305 S. Congress PUD

Presentation
to the
Parks and Recreation Board
August 5, 2021

Atha Phillips
Environmental Program Coordinator
Environmental Officer's Office

Scott Grantham
Planner Principal, Park Planning
Parks & Recreation Department

Staff Evaluation

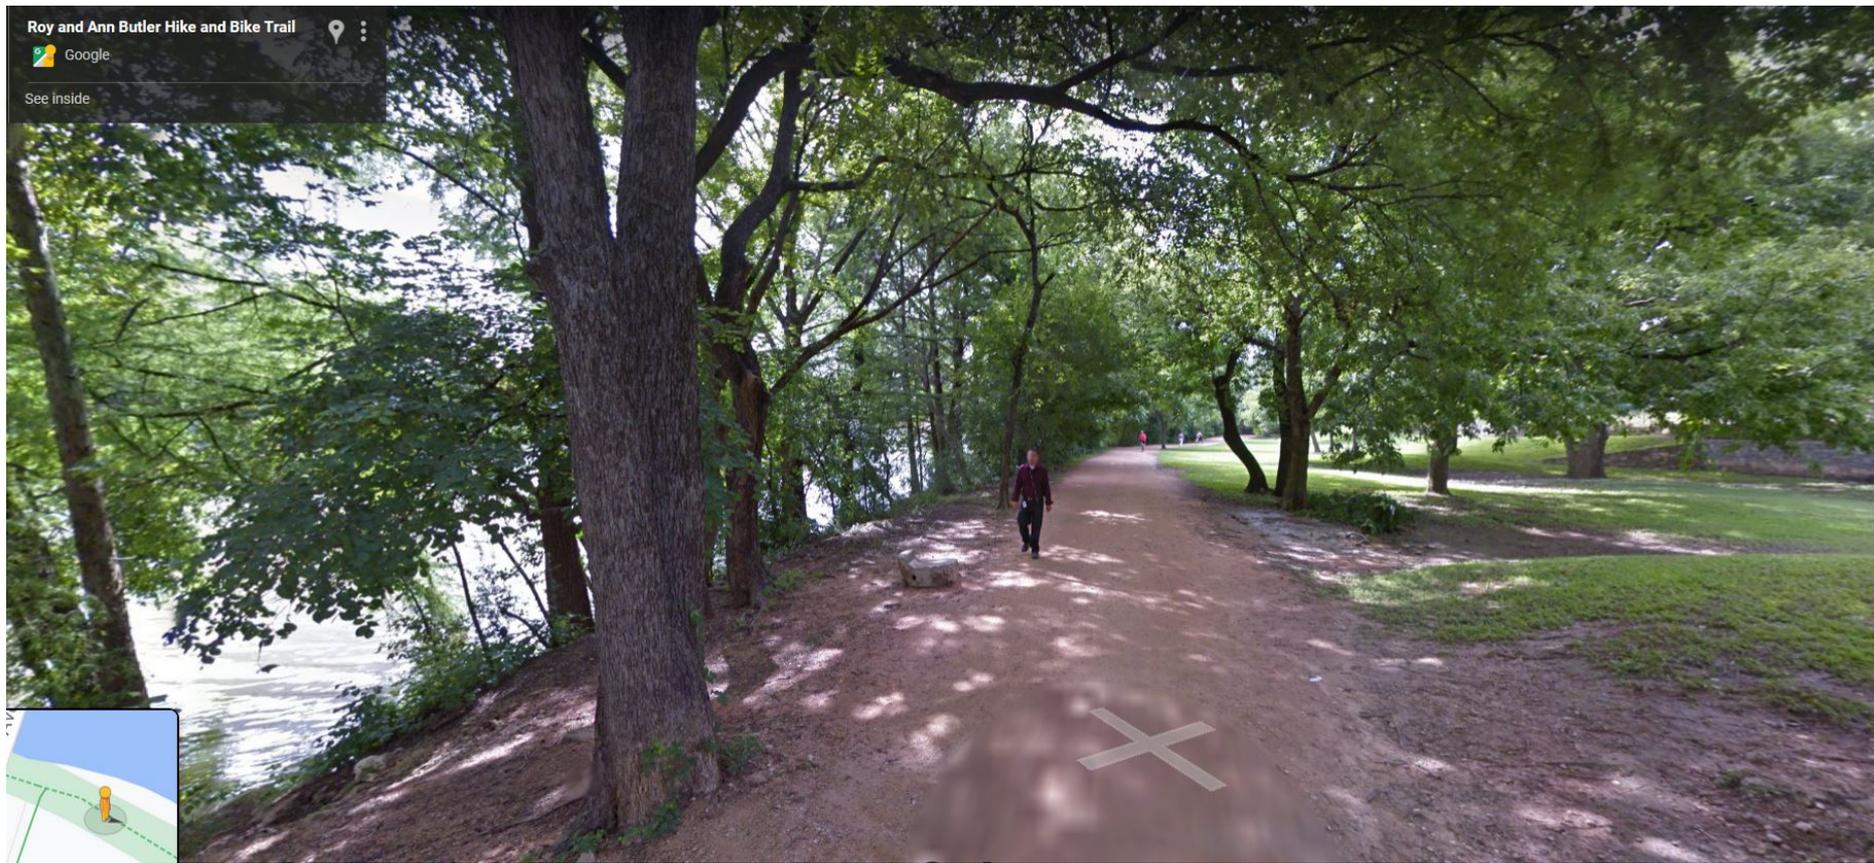
1. Applicant has committed to deeded parkland, which will remain in the Public's hands in perpetuity. Park easements on plazas will ensure these areas are public.

2. Timing for dedication and park construction is unclear. Applicant has offered ideas, but further discussion is needed.
3. Specificity of commitment to build park amenities. Current code would require park development; superiority would mean committing to build in excess, on a per unit basis. (e.g. >+\$200 per unit), and making improvements clear on plans.

4. Ponds in Parkland, especially if fenced and not designed as amenities. Special focus on Bat Viewing Area.
5. Over-development of the area in the CWQZ and floodplain. Redundant concrete paths along with proposed vending in the future will exacerbate erosion.

6. Staff understands the need for a public viewing area and heavier programming on the west side of the park. Staff has offered in exchange for more development on the west side of the park and for the east side to be restored to a natural state. This would include relocating the trail a minimum of 25' from the shoreline and moving all water quality to this area.

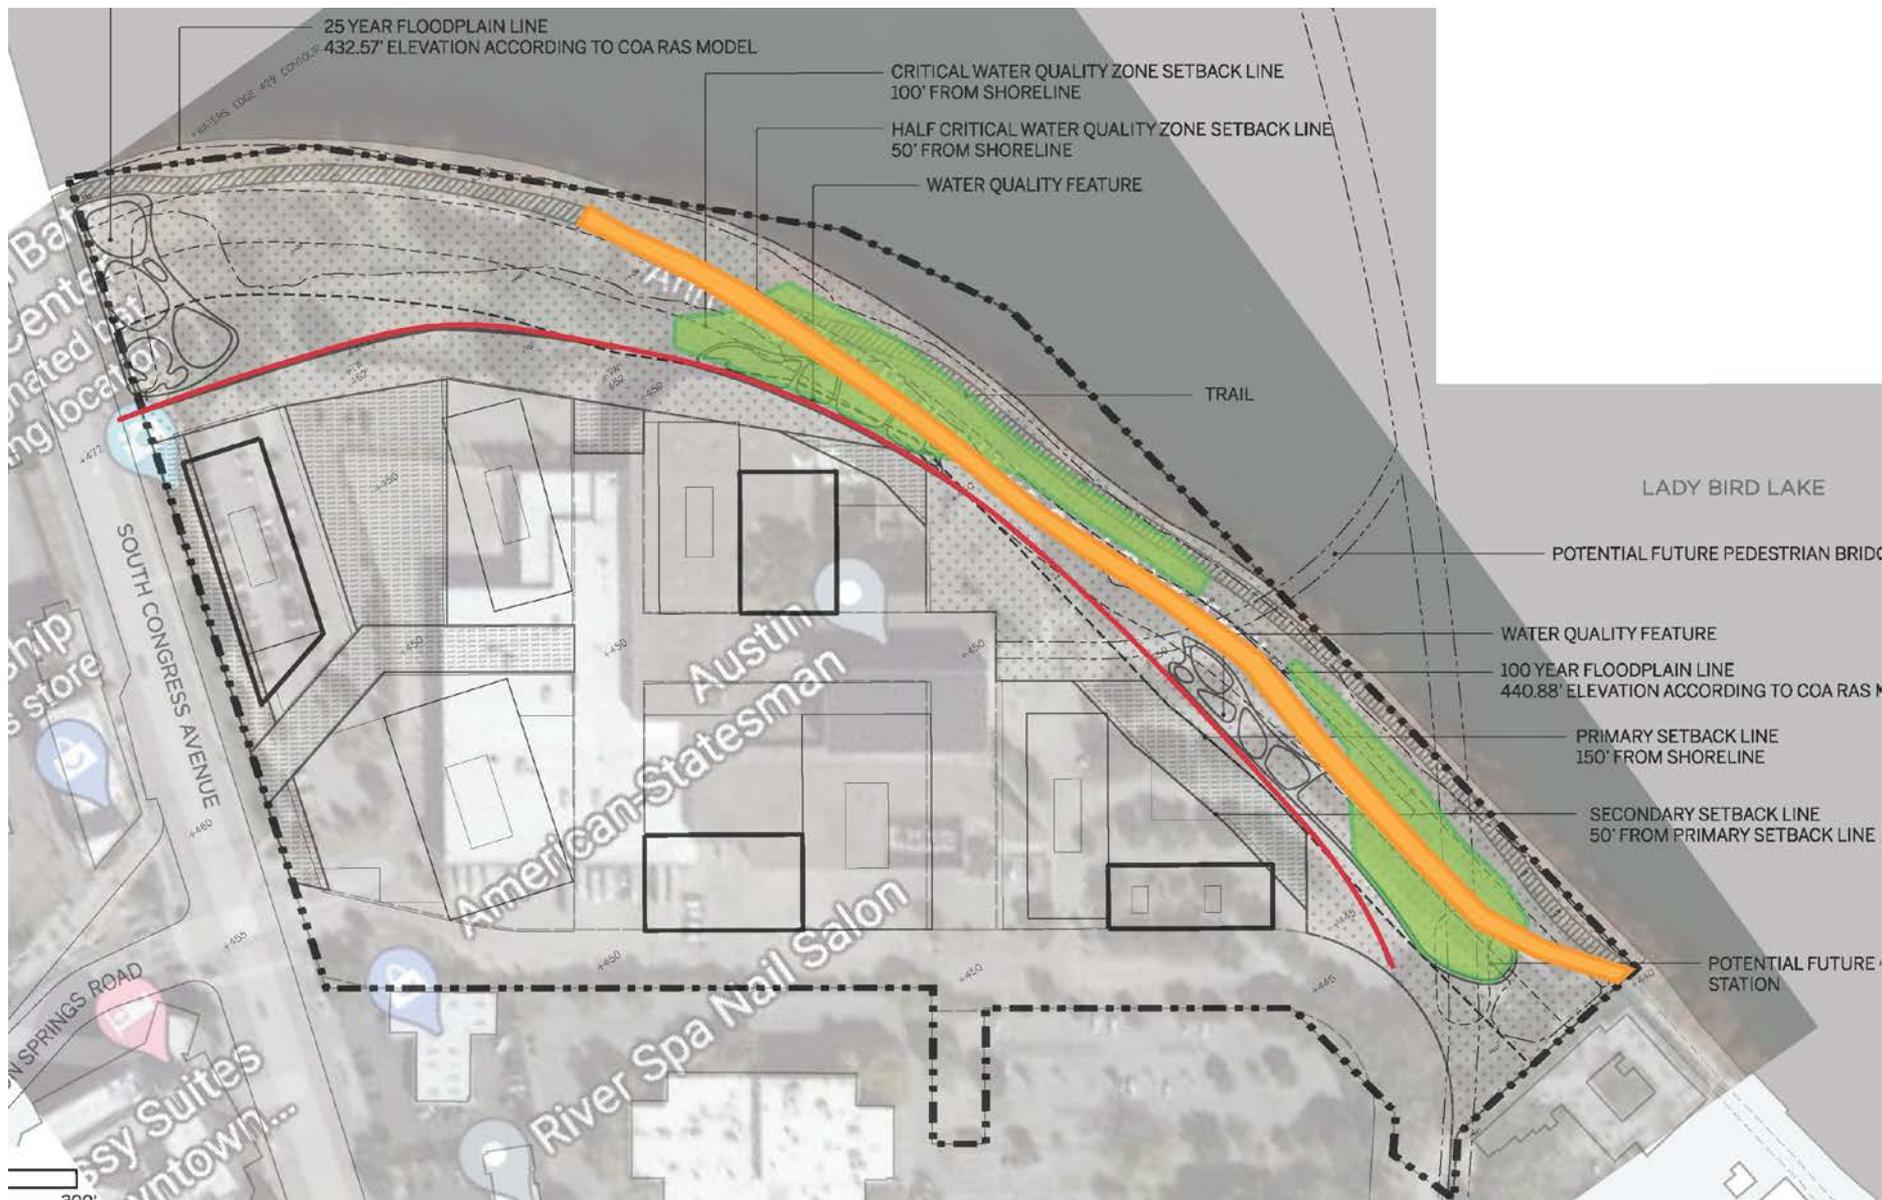
On the eastern half of the property, the trail lies on the edge of the shoreline and is causing erosion downslope. Staff suggests that the trail be moved a minimum of 25' from the shoreline in these areas. The area between the trail and the shoreline should be restored.

In exchange for denser development on the west side for bat viewing, staff proposes moving the trail off the shoreline as shown. Staff also proposes moving all water quality ponds as shown and integrating the rain gardens with restoration, alleviating the need for a deep biofiltration pond in the bat viewing area.

5. Complete a Parkland Improvement Agreement, including maintenance for water quality ponds located within the parkland.
6. Relocate the trail a minimum of 25' from the edge of the shoreline except at approved shoreline access points and restore the area between the shoreline and trail with riparian or wetland vegetation on the east side, refer to Exhibit.
